S55-06/07

Proponent: James S. Lai, LAI Associates

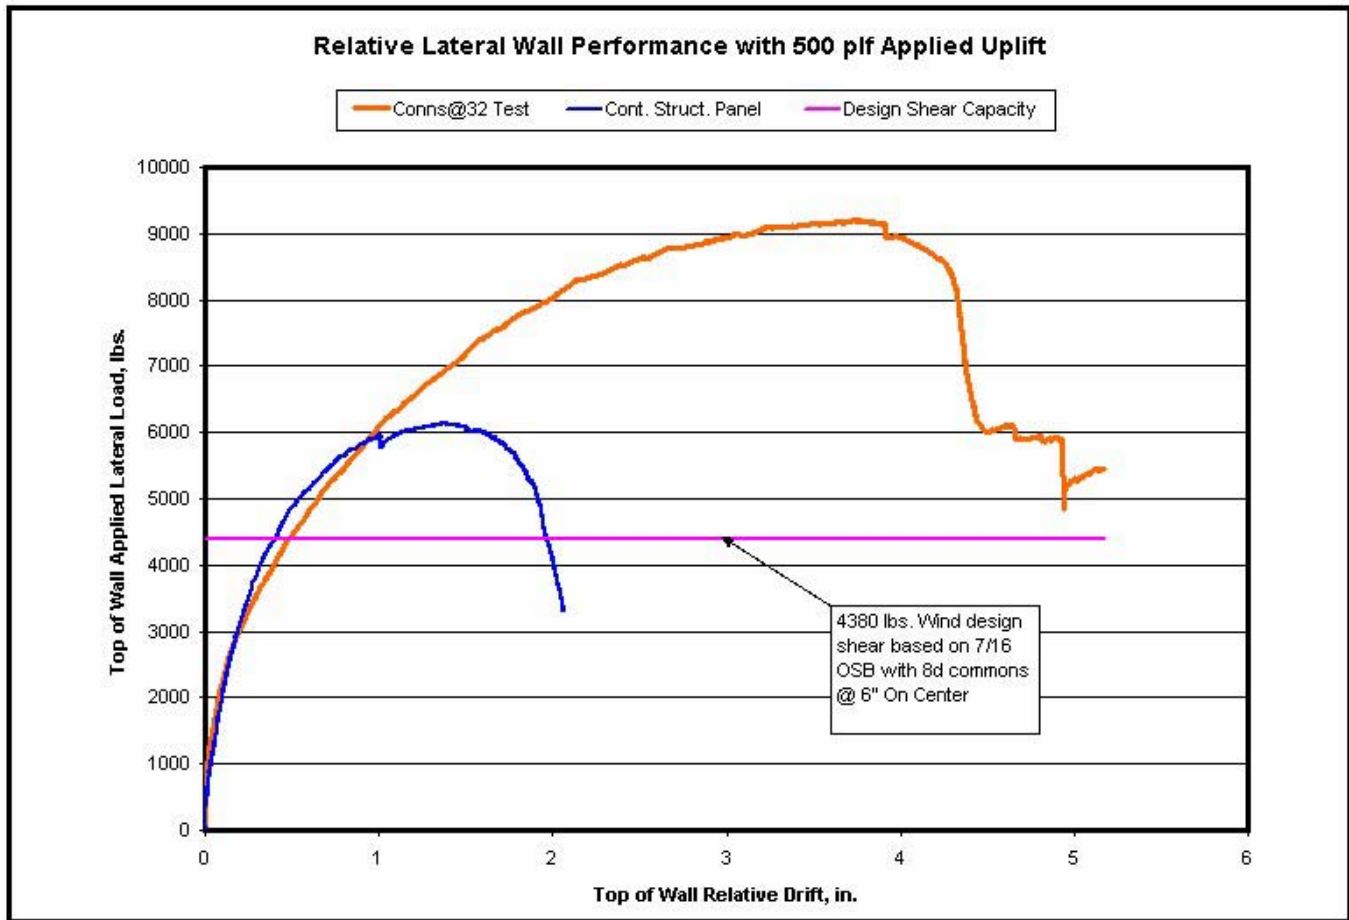
The purpose of Item 2 is to add a limitation to the code. Perforated shear wall segments already transfer both shear forces and uplift forces into the sill plate along their entire length (See Section 2305.3.8.2.6), so there is not additional capacity to transfer any wind uplift force without reducing the shear capacity.

The graph below shows the reduction in shear capacity of a shear wall that is designed for and subjected to combined uplift and shear simultaneously, compared to the same wall subjected to the same loads that uses connectors to resist the uplift.
